Accessibility Plan Review

Nexus Vue Apartments
Spartanburg, SC

April 7, 2023 | F8226212

**RE: Accessibility Plan Review Report
Nexus Vue Apartments**
W. Blackstock Road & Morning Circle
Spartanburg, SC
Terracon Project Number F8226212

#4 - Units A-2, B-6 & C-1 Type B

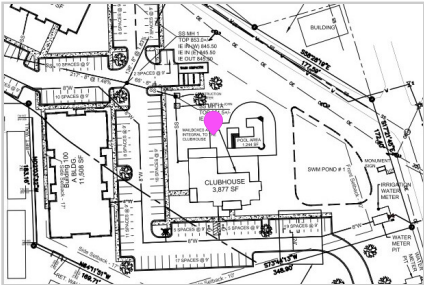
Emmanuel Belleau	Issue: Ensure electrical outlets in the kitchen are within 46" from finish floor. All other outlets should be a minimum of 15" from finish floor to the bottom outlet. All switches and thermostats should be a maximum of 48" from finish floor.	07 Mar 07:16 AM
Emmanuel Belleau	General Comment: Ensure that the toilet is centered 16" to 18" from the finish face of the adjacent wall.	07 Mar 07:17 AM
Emmanuel Belleau	Issue: Ensure that there is blocking provided around the toilets and showers or tubs to allow for installation of future grab bars, if needed.	07 Mar 07:20 AM
Emmanuel Belleau	General Comment: Ensure there is a low-profile threshold installed at the entrance to the apartment and either low-profile threshold or an adaptable threshold with a maximum 4" change in level installed at the patio.	07 Mar 08:01 AM
Emmanuel Belleau	Issue: Ensure that the kitchen will have a 40" maneuvering clearance between all opposing base cabinets, countertops, appliances, and walls. Minimum dimensions are recommended at the kitchen island.	04 Apr 02:16 PM

#1 - Parking

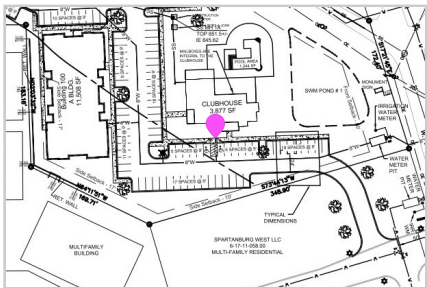
Emmanuel Belleau	Issue: Per a calculation of 2% of the total 440 parking spaces, it appears that a minimum of nine (9) accessible parking spaces should be provided. It appears that seven (7) are accounted for in the plans. Please review.	06 Mar 01:32 PM
Melissa Middleton	Issue: A van-accessible parking space did not appear to be delineated on the site plan near the Leasing Office. Please review.	04 Apr 01:59 PM

#12 - Restroom Mirror Details

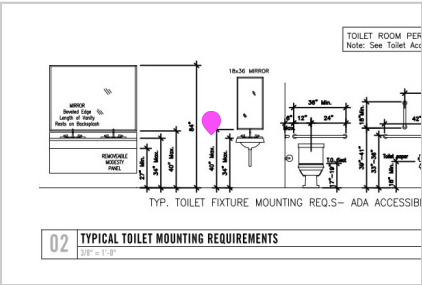
Melissa Middleton Issue: The mirror should be located a maximum of 40" from finish floor to the reflective surface versus the bottom of the mirror frame. 14 Mar 03:40 PM

#13 - Restroom Lavatory Counter Height

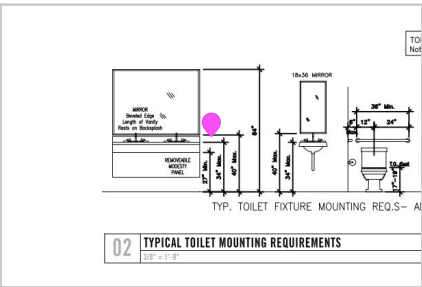
Melissa Middleton Issue: Per the details, the counter is noted to be within 34" from finish floor; however, the rim of the lavatory should be within 34" from finish floor. Please review. 14 Mar 03:44 PM

#14 - Restroom Toilet Paper Location

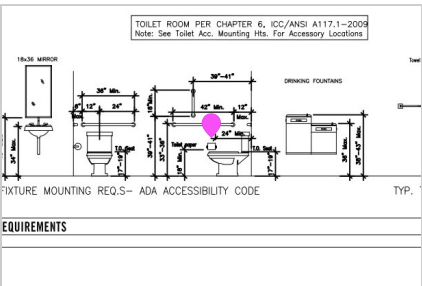
Melissa Middleton Issue: The toilet paper dispenser should be located 7" to 9" forward from the lip of the toilet to the center of the dispenser. 14 Mar 03:46 PM

#16 - Drinking Fountain Height

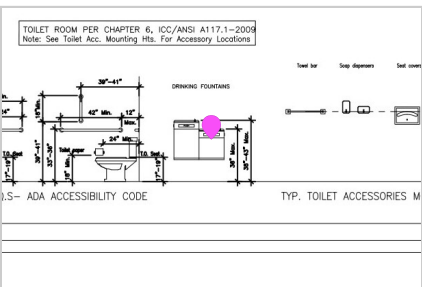
Melissa Middleton Issue: Provide the dimension for the minimum knee clearance at the low drinking fountain of 27". 14 Mar 03:50 PM

#17 - Restroom Toliet Location

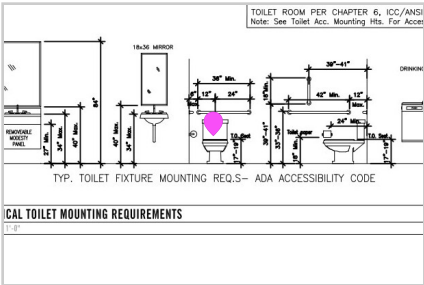
Issue: The location of the toilet is not noted in the details. Please provide.

#18 - Car Wash & Dog Wash

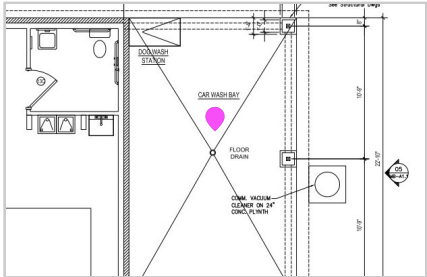
Melissa Middleton	Issue: Elevations of the car wash controls, vacuum controls and dog wash station are not provided for review. Ensure that the elements are within 15" to 48" from grade and along an accessible route.	04 Apr 02:06 PM
-------------------	--	-----------------

#9 - Trash Compactor

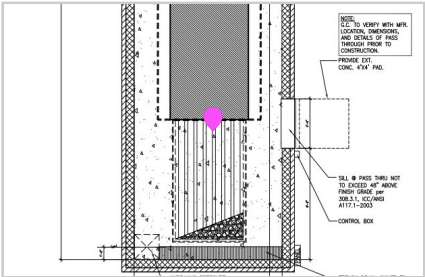
Emmanuel Belleau	Issue: Elevations and a detailed plan should be provided to illustrate the accessible route and access to the compactor. Per the site plan, the opening for the trash compactor should be on the opposite side. In addition, review the chute opening. The reach range should not extend more than 2'-0". The height of the opening should be within 48" from the ground floor if the depth is within 10" or 46" if the depth is between 10" and 24".	08 Mar 07:21 AM
Melissa Middleton	Issue: The elevation details of the compactor controls are not provided. The controls should be within 15" to 48" from the ground surface.	14 Mar 03:23 PM

● **#10 - Building 800: Curb Ramp**
Plan Review | Emmanuel Belleau | Site-Paths
Plan: CV-5 - Site Utility Plan | Location: Parking

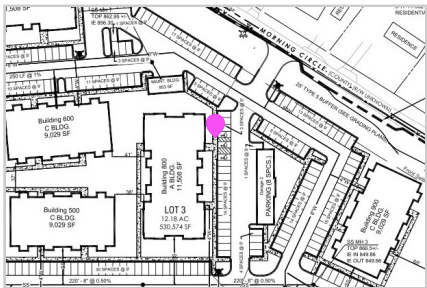
Task messages (time in EDT)
Emmanuel Belleau Issue: Missing curb ramp details at the accessible parking spaces.

#2 - Unit B-6 Type A

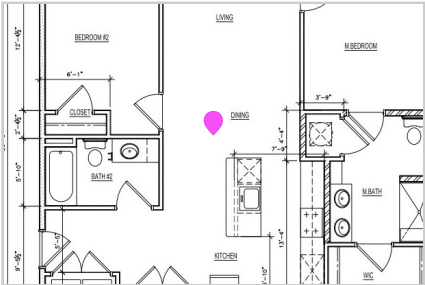
Emmanuel Belleau	Issue: Toilet paper dispenser should be installed 7" to 9" from the front of the toilet.	06 Mar 01:52 PM
Emmanuel Belleau	General Comment: Ensure that the toilet is centered 16" to 18" from the finish face of the adjacent wall.	06 Mar 01:53 PM
Emmanuel Belleau	Issue: Provide elevations for the blocking to be installed near the toilet, tub and/or shower.	06 Mar 02:04 PM
Emmanuel Belleau	Issue: Ensure that the pantry depth is no more than 24" from the the face of the exterior wall to the back of the pantry.	06 Mar 02:11 PM
Emmanuel Belleau	Issue: All work surfaces and sinks should be within 34" from finish floor, this includes the kitchen sink and bathroom lavatory. The cabinets and sinks should allow for a 27" knee clearance.	06 Mar 02:25 PM
Emmanuel Belleau	Issue: Ensure the electrical outlets in the kitchen are within 44" from finish floor. All other outlets should be a minimum of 15" from finish floor to the bottom outlet. All switches and controls for the thermostats should be a maximum of 48" from finish floor.	06 Mar 02:54 PM

Emmanuel Belleau	General Comment: Ensure there is a low-profile threshold installed at the entrance to the apartment as well as at the patio.	07 Mar 06:53 AM
Emmanuel Belleau	Issue: Ensure that the shelves within the closets have a reach range within 15" to 48" from the finish floor.	07 Mar 07:34 AM
Emmanuel Belleau	Issue: The electrical panel should be installed a maximum of 48" from finish floor to the top breaker.	07 Mar 07:37 AM
Emmanuel Belleau	Issue: It is unclear if the washer and dryer are either top- or front-loading. Confirm the clear floor space at each appliance either centered on a top-loading appliance or offset on a front-loading appliance.	04 Apr 02:47 PM
Emmanuel Belleau	Issue: Ensure that the kitchen will have a 40" maneuvering clearance between all opposing base cabinets, countertops, appliances, and walls. Minimum required dimensions are recommended at the kitchen island.	04 Apr 03:16 PM

Emmanuel Belleau	Issue: Provide elevations for the blocking to be installed near the toilet, tub and/or shower.	04 Apr 04:02 PM

#3 - Door and Window Schedules

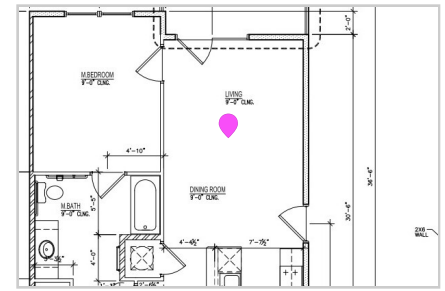
Emmanuel Belleau	Issue: Missing sheets A9.1 and A9.2 which provide the door and window schedules. Ensure that the egress windows have controls within the reach range.	07 Mar 07:00 AM
------------------	---	-----------------

#5 - Unit C-1 Type A

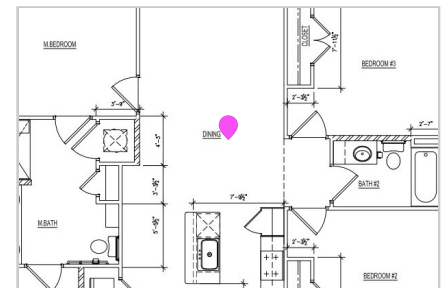
Emmanuel Belleau	Issue: Ensure the electrical outlets in the kitchen are within 44" from finish floor. All other outlets should be a minimum of 15" from finish floor to the bottom outlet. All switches and controls for the thermostats should be a maximum of 48" from finish floor..	07 Mar 08:37 AM
Emmanuel Belleau	Issue: All work surfaces and sinks should be within 34" from finish floor, this includes the kitchen sink and bathroom lavatory. The cabinets and sinks should allow for a 27" knee clearance.	07 Mar 08:37 AM
Emmanuel Belleau	Issue: The electrical panel should be installed a maximum of 48" from the finish floor to the top breaker.	07 Mar 08:38 AM
Emmanuel Belleau	Issue: Toilet paper dispenser should be installed 7" to 9" from the front of the toilet.	07 Mar 08:40 AM
Emmanuel Belleau	Issue: Ensure that the kitchen will have a 40" maneuvering clearance between all opposing base cabinets, countertops, appliances, and walls. Minimum required dimensions are recommended at the kitchen island.	07 Mar 08:47 AM

Emmanuel Belleau	Issue: It is unclear if the washer and dryer are either top- or front-loading. Confirm the clear floor space at each appliance, either centered on a top-loading appliance or offset on a front-loading appliance.	07 Mar 08:50 AM
Emmanuel Belleau	Issue: Ensure that the shelves within the closets have a reach range within 15" to 48" from the finish floor.	07 Mar 08:53 AM

Emmanuel Belleau	General Comment: Ensure there is a low-profile threshold installed at the entrance to the apartment as well as at the patio.	07 Mar 08:54 AM
Emmanuel Belleau	Issue: Provide elevations for the blocking to be installed near the toilet, tub and/or shower.	04 Apr 02:52 PM

● #6 - Units B-6 and C-1 Type A: Shower Control

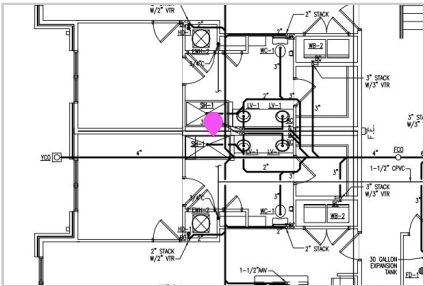
Melissa Middleton	Issue: Confirm the location of the shower controls in the roll-in shower. From the architectural unit plan, a seat appears to be provided; therefore, the controls should be on the back wall near the seat within 27" of the seat wall. Please review.	04 Apr 02:34 PM
-------------------	---	-----------------
